Informal document **GRSG-126-33**
(126th GRSG, 10– 13 October 2023
Agenda item 4(e))

126TH UNECE GRSG: POTENTIAL AMENDMENT TO ENSURE FRONTAL DIRECT VISION REQUIREMENTS IN UNECE REGULATION 167

DR STEVE SUMMERSKILL

Original vehicle design

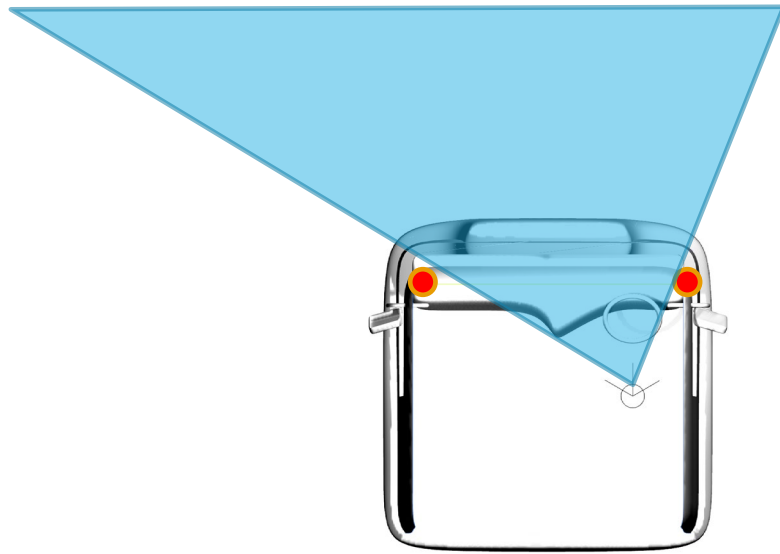
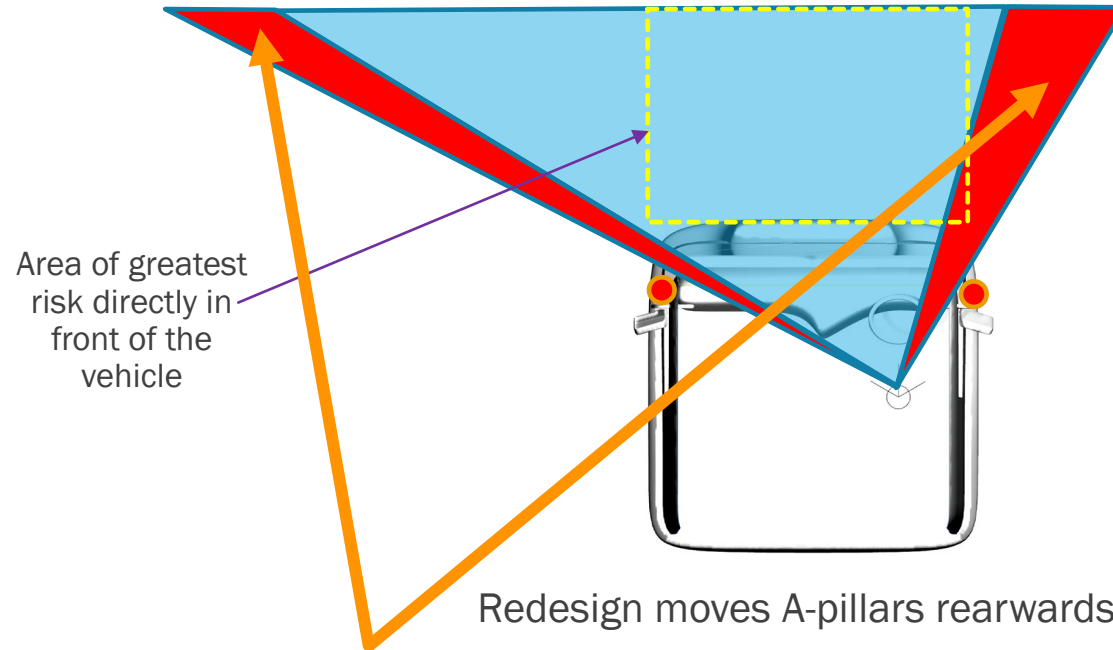
- If manufacturers choose to move the A-pillars rearwards towards the driver compared to the original sample they will be able to gain volume without improving the view of the area of greatest risk
- i.e. the design could do nothing to improve the visibility of VRUs directly in front of the vehicle in the area of greatest risk and still meet frontal minimum requirements

Red areas show volume gained outside of area of greatest risk for frontal collisions, **potentially allowing a vehicle to pass the minimum requirements without improving direct vision directly in front of the vehicle in the area of greatest risk.**

Redesigned dashboard on the passenger side

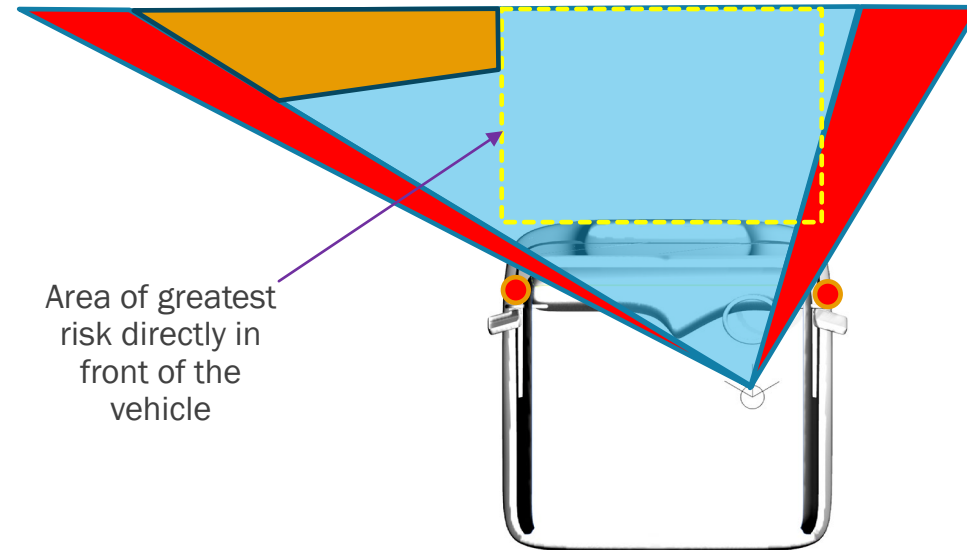
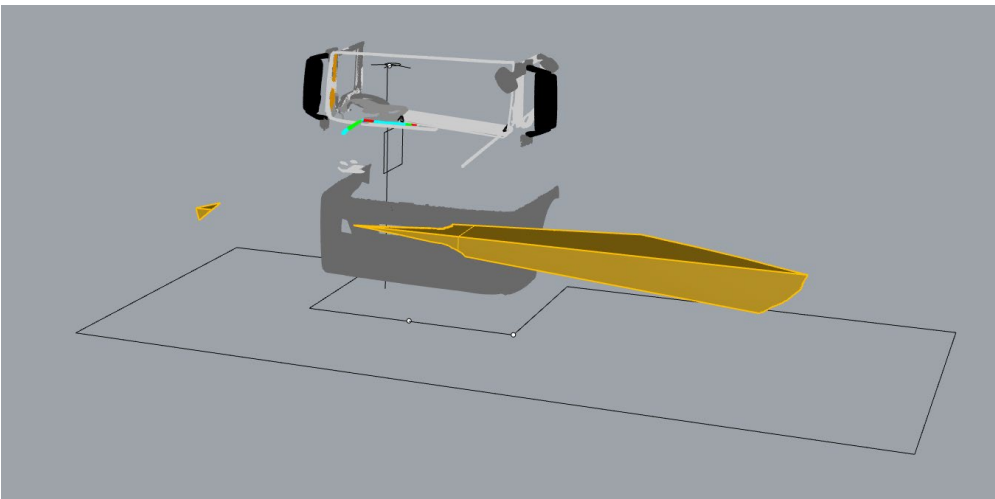
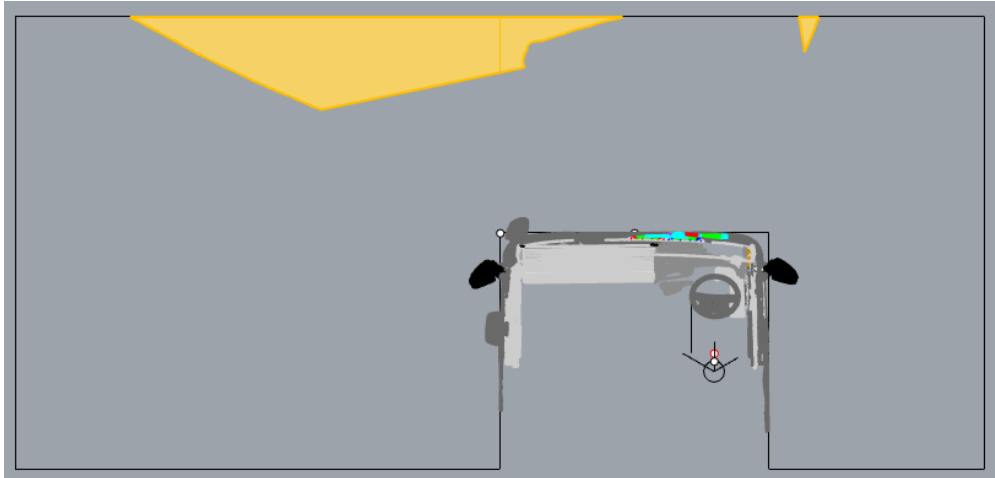
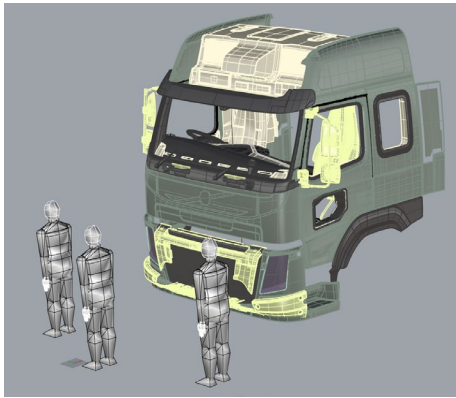
- In addition, further volume can be gained by lowering the passenger side dash board area, but this volume is also outside of the area of greatest risk. This approach has been suggested by ACEA

Orange areas show volume gained outside of area of greatest risk for frontal collisions, **potentially allowing a vehicle to pass the minimum requirements without improving direct vision directly in front of the vehicle in the area of greatest risk.**

- 
- We therefore designed a new method to ensure that the intent of the standard is met (to allow the VRUs in front of the vehicle to be seen) as per the content in the next three slides.

Redesign moves A-pillars rearwards

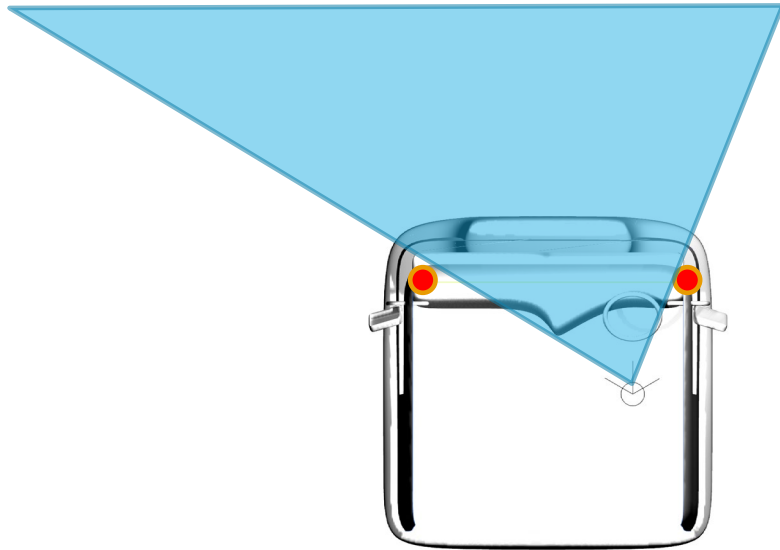
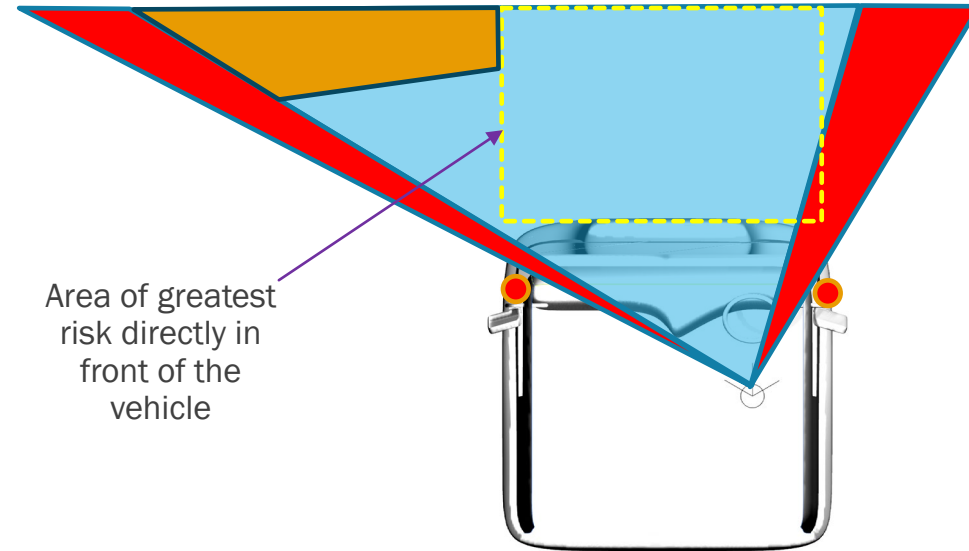
Red areas show volume gained outside of area of greatest risk for frontal collisions, potentially allowing a vehicle to pass the minimum requirements without improving direct vision directly in front of the vehicle.

- By requiring a design to allow visibility of the **Subsection Frontal Visible Volume (SFVV)** area we can avoid the issue shown below.

Replace Annex 4 Figure 1 with the following which shows the SFVV:

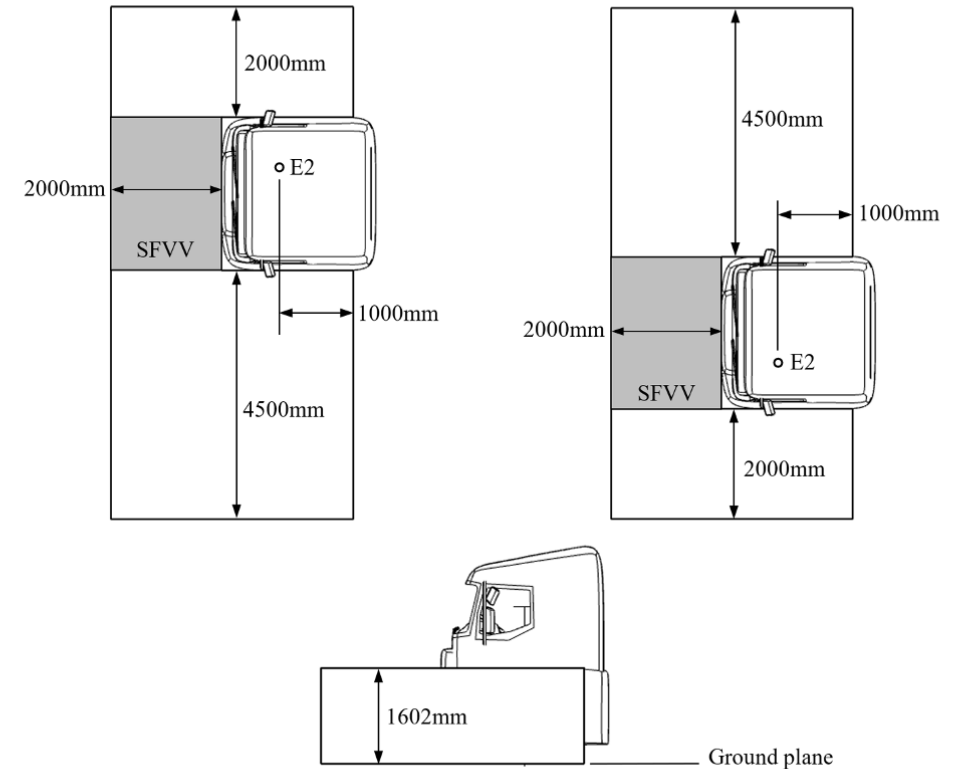
- The proposed amendment adds requirements for specific volumes to be seen directly in front of the vehicle in the Subsection Frontal Visible Volume (SFVV)
